# Woollahra Local Planning Panel (Public Meeting)

## **LOCAL PLANNING PANEL DEVELOPMENT APPLICATION ASSESSMENT REPORT**

THAT the Woollahra Local Planning Panel, exercising the functions of Council, as the consent authority, refuse development consent to Development Application No. 250/2023/1 for demolition of the existing dwelling and the construction of a new two-storey dwelling with basement storage a swimming pool and associated landscaping on land at 38 Russell Street Vaucluse, for the following reasons:

ROOF PLAN

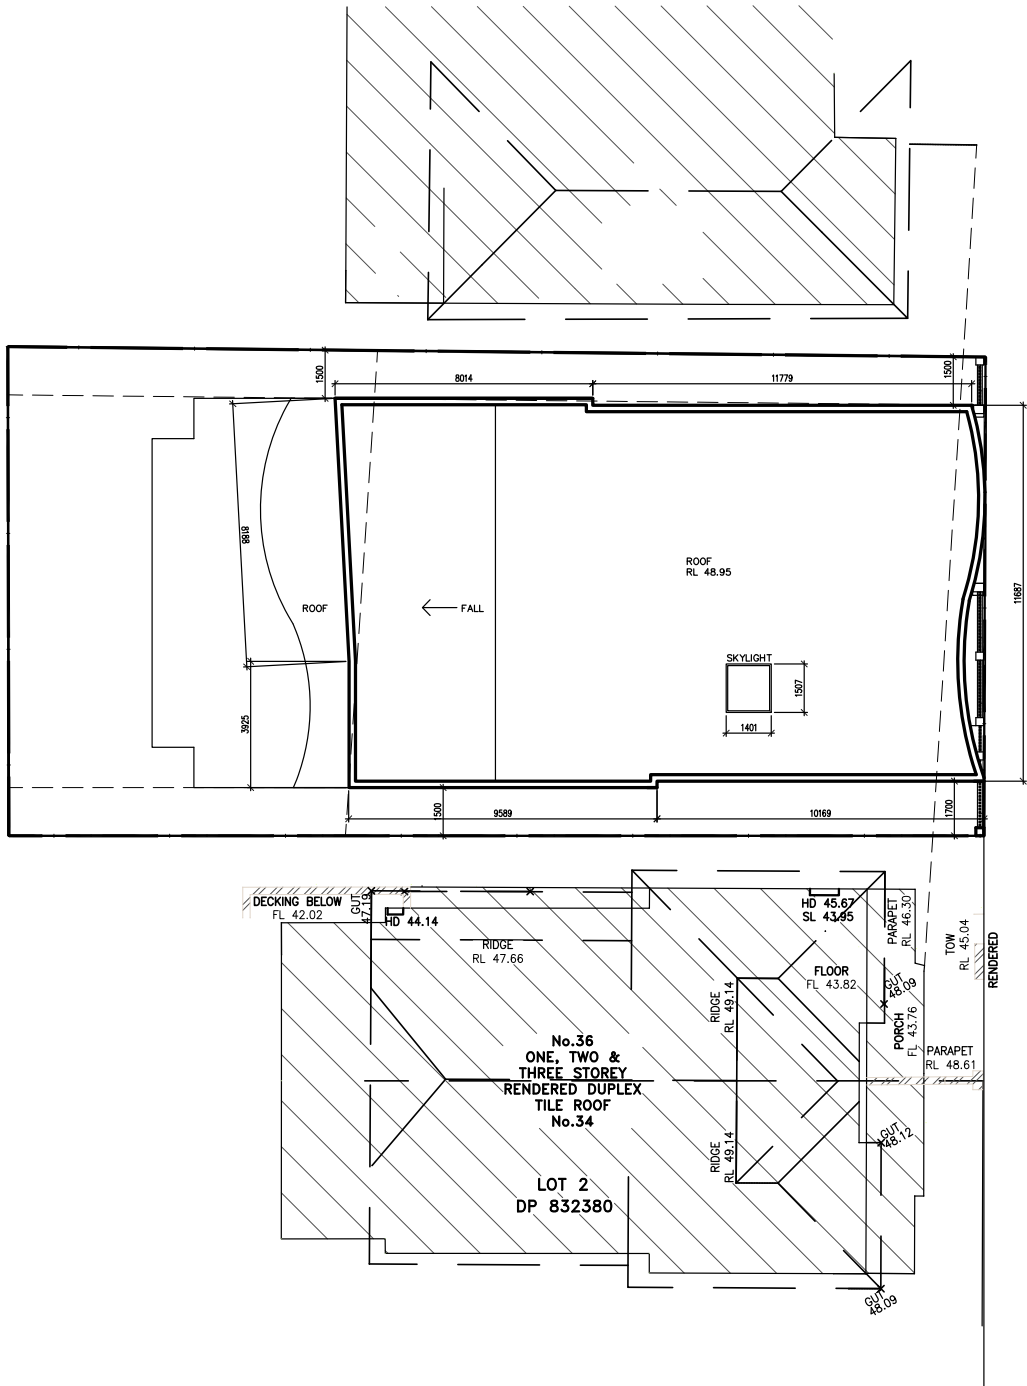
The submitted architectural plans and landscape plan are inconsistent. The landscape plan appears to show a rooftop roof terrace and states the parapet walling is to create planters for a rooftop garden. Whereas, the architectural plans does not show the roof terrace or any associated access or balustrading. The architectural plans also show the proposed parapet height to be 200mm, which does not allow for sufficient soil depth to support the proposed rooftop garden.

In addition the submitted architectural plans do not show any lift over-run or any associated lift plant. It is unclear if any other equipment such as air conditioning or solar panels are proposed to be located on the proposed roof. It is noted that the submitted BASIX Certificate states that air conditioning and solar panels are proposed by development, however these elements have not been shown on the architectural plans.

- The landscape plans and the architectural plans are inconsistent as follows:
  - i. The landscape plans show a roof terrace to the top of the dwelling. No roof terrace or any associated balustrading or access to this roof terrace is shown on the architectural plans;

- ii. The landscape plans state the rooftop parapet is to create a planter for the rooftop planting, whereas the architectural plans only show a parapet height of 200mm (this is insufficient to accommodate sufficient soil depth to support this rooftop planting);

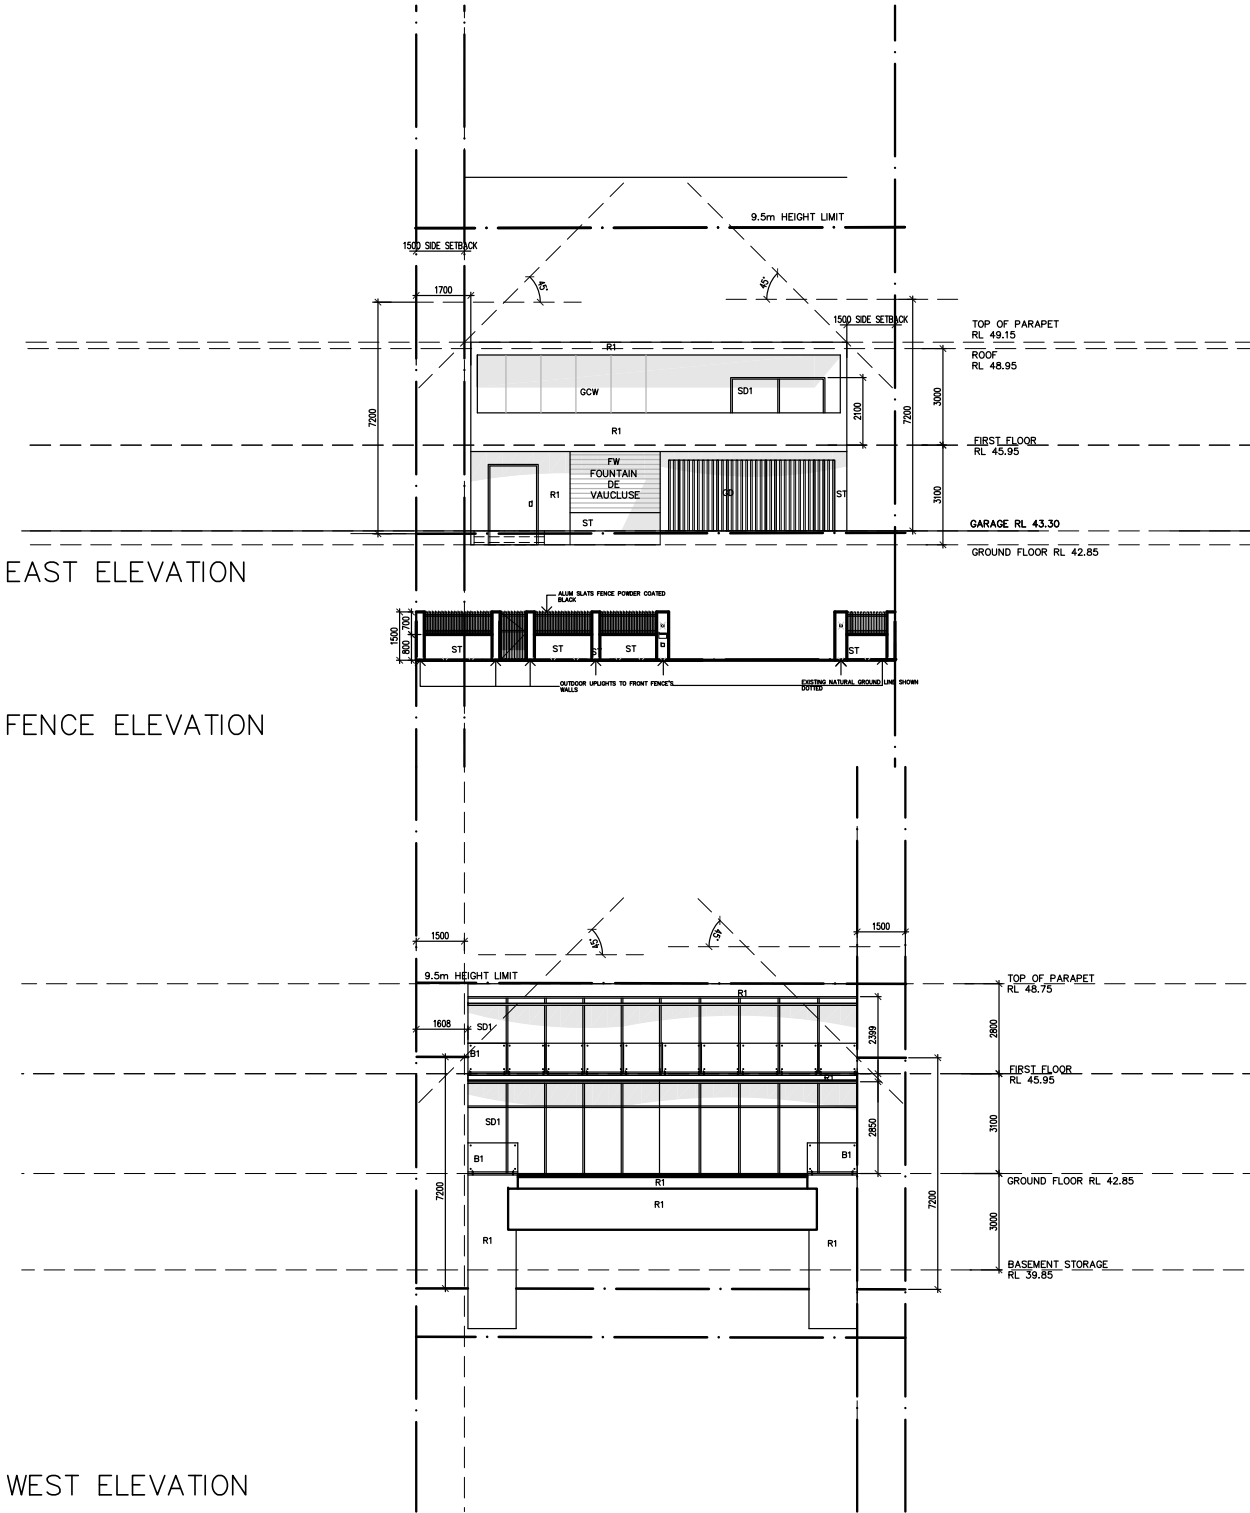
It is noted that the privacy impacts created by the proposed first floor rear balcony are unable to be adequately assessed, as the submitted floor plans/section and the elevations are inconsistent. The elevations show this balcony to be approximately 1m wider than what is shown on the floorplan/section. In addition the applicant has not provided any sight line drawings to demonstrate whether this balcony will overlook the rear adjoining private open space. It would appear that there is no sightline into these properties from this balcony.

- The rear elevation does not show the proposed swimming pool fence.

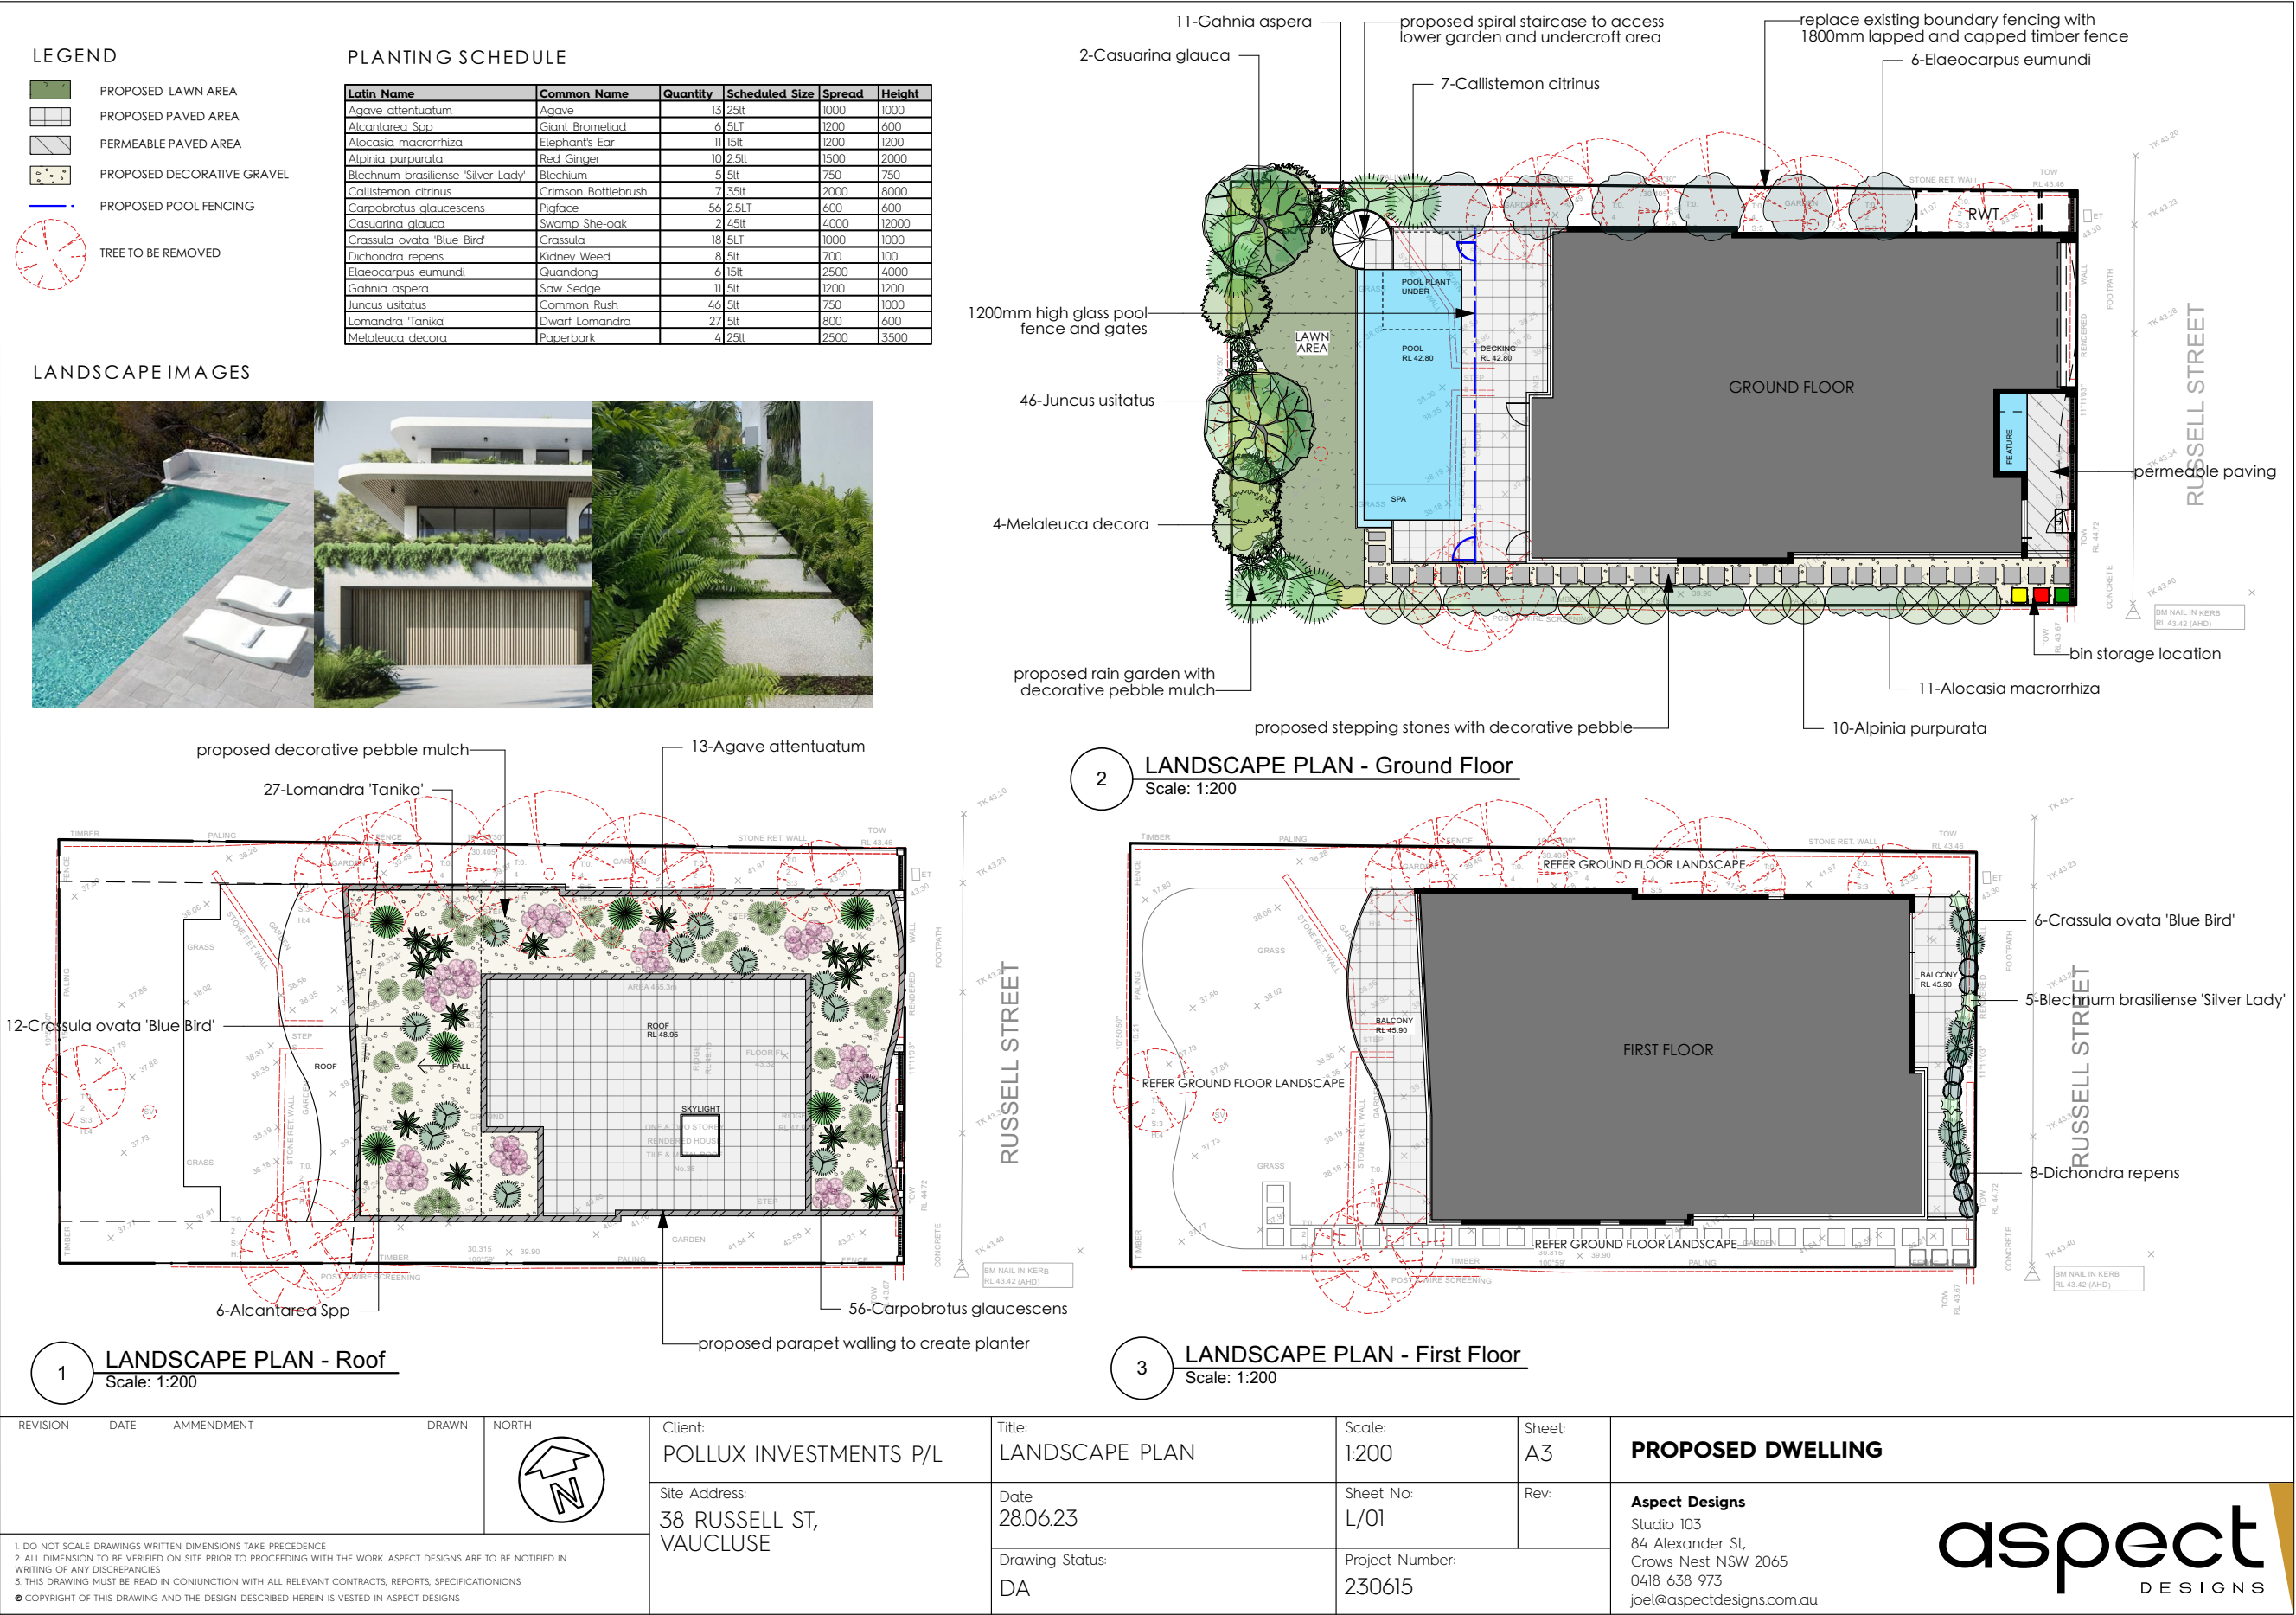
The proposed landscape plan notes that the boundary fencing is to be replaced with new 1.8m lapped and capped timber fencing. However this fencing is not shown on the submitted architectural plans, which does not allow for these works to be adequately assessed, particularly given the steeply sloping nature of the site. It also noted that according to the submitted survey that the existing boundary fencing encroaches over the site boundaries. The applicant has not provided owners consent to allow for any works on these adjoining properties to be carried out. The proposed development is considered to be unacceptable in this regard.

- iii. The landscape plan shows an external spiral staircase adjacent to the proposed swimming pool providing access to the rear garden. This staircase is not shown on the architectural plans;
